Proposed: House and Septic Tank

Plans lodged: Additional Information - New layout

Register Reference : 91A/0948

Development : Bungalow and septic tank  
LOCATION : Redgap, Rathcoole, Co. Dublin  
Applicant : Patrick Rochford  
App. Type : PERMISSION/BUILDING BYE-LAW APPROVAL

SITE LAYOUT MAP FOR  
 P. J AND ESTHER ROCKFORD  
 AT SPRINGHILL, RED GAP,  
 RATHCOOLE, CO. DUBLIN.  
 SCALE 1" TO 48' FT.

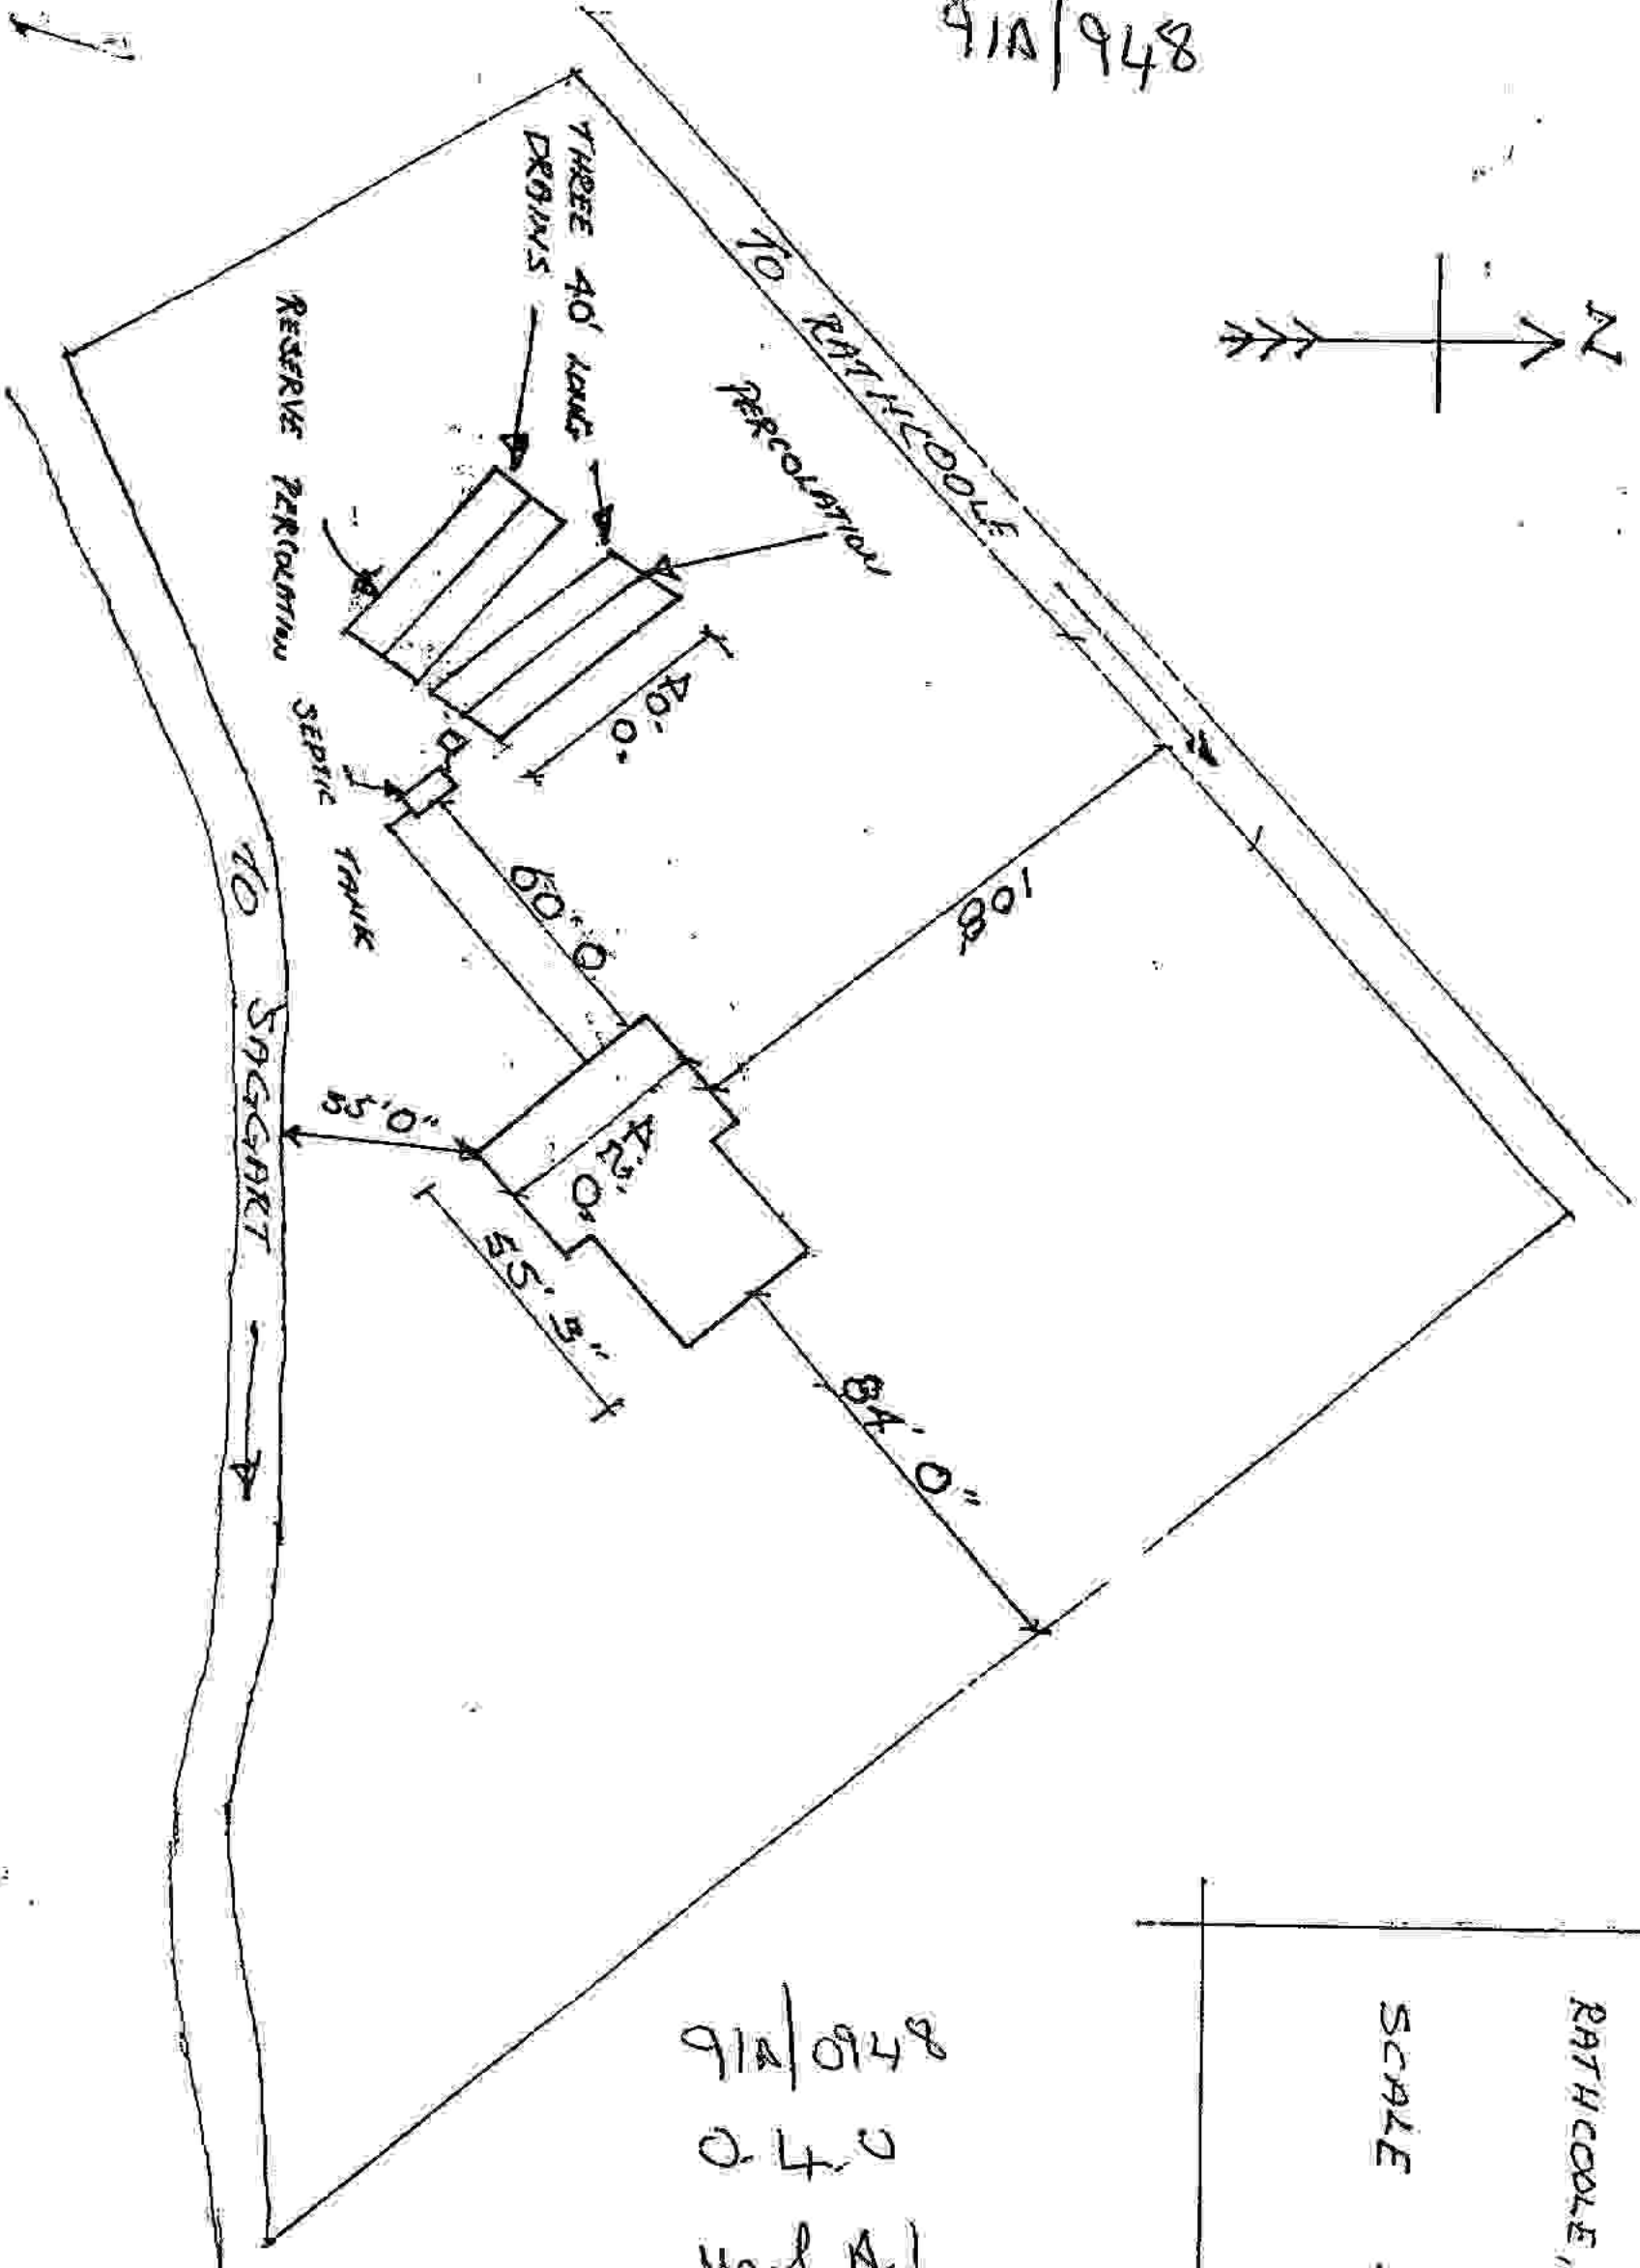
- (1) evidence of an adequate and potable water supply to be submitted.
- (2) A detailed plan of the septic tank to be submitted.

I inspected two trial holes opened in the revised locations. 6'6" deep - dry soil appeared suitable for the treatment of septic tank effluent.

SITE LAYOUT MAP FOR  
P.J AND ESTHER ROCKFORD  
AT SPRINGHILL, RED ZAP,  
RATHCOOLE, CO. DUBLIN.  
SCALE 1" TO 48' FT.

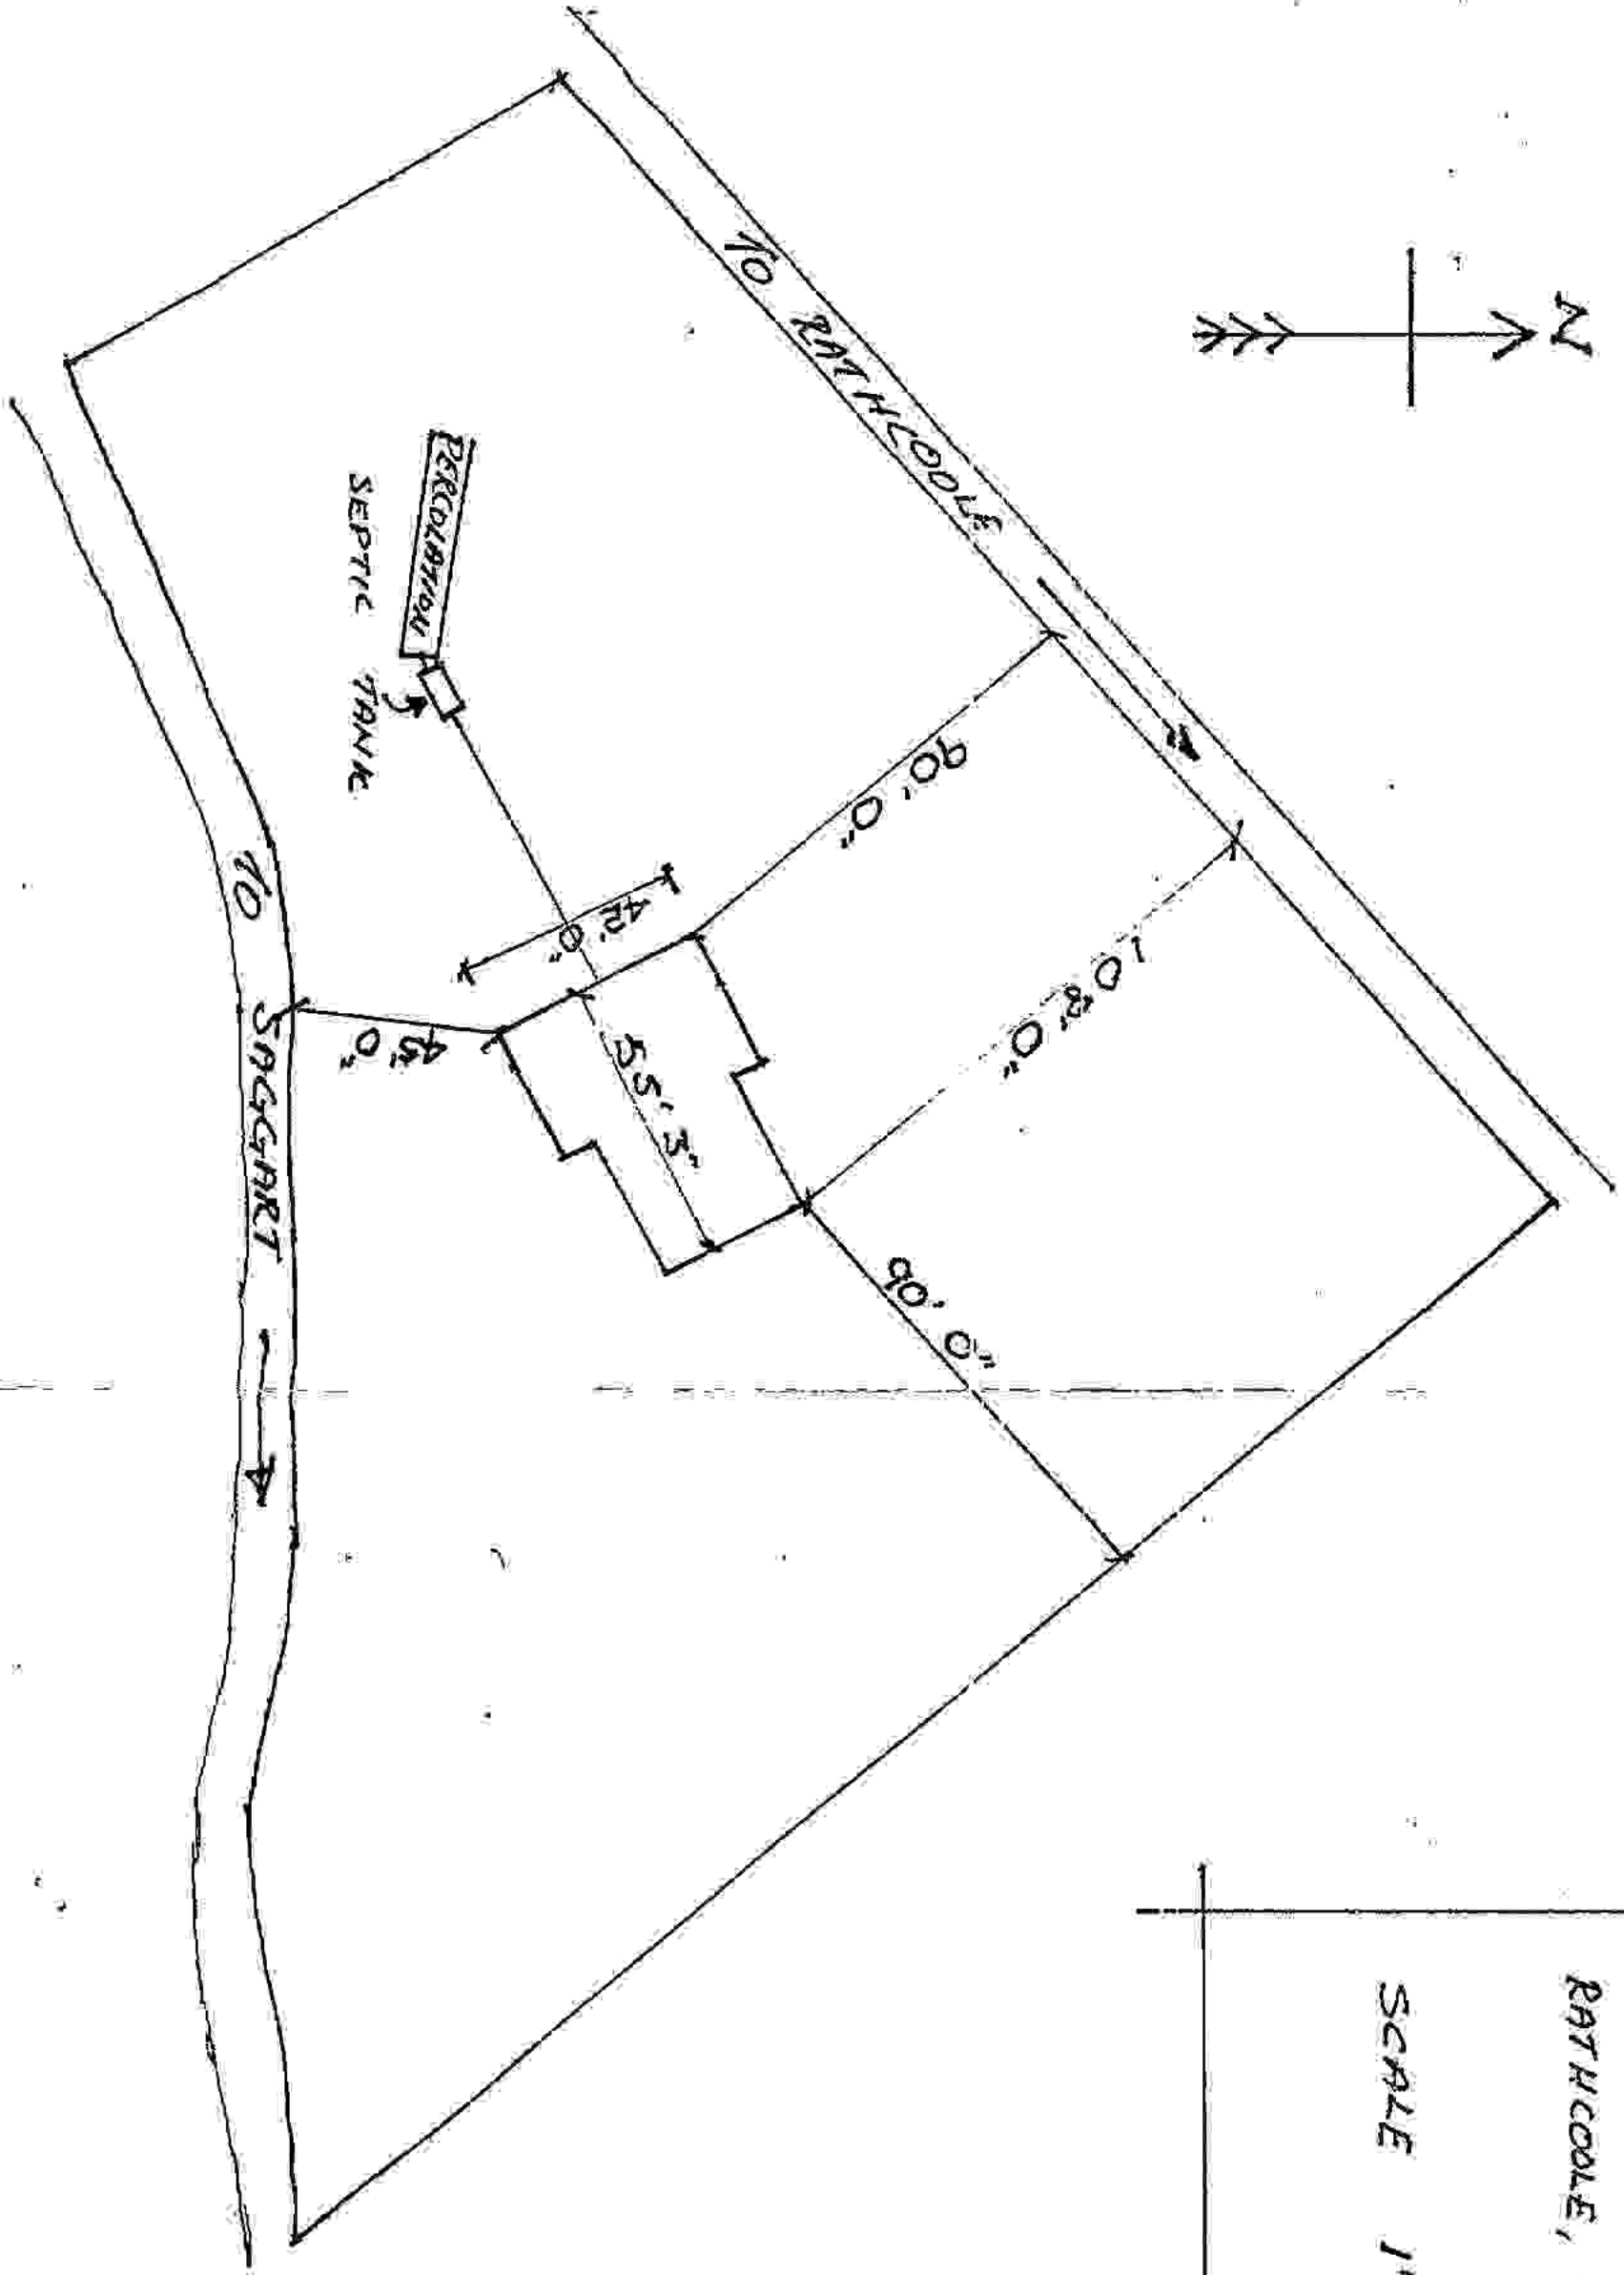
- (1) There is no reserve percolation area indicated on the plan.
- (2) Evidence of an adequate and reliable water supply has not been submitted.
- (3) A detailed plan of the septic tank was not provided.
- (4) The location of septic tanks, percolation areas, reserve percolations and wells in adjoining sites not submitted.
- (5) Two TRIAL HOLES were inspected on the 22/8/91. 6'6" Deep Dry. A lot of stone and shingle, not suitable for the treatment of septic tank effluent.

NOTE: ① No details of percolation area provided  
② No Reserve Percolation area indicated.
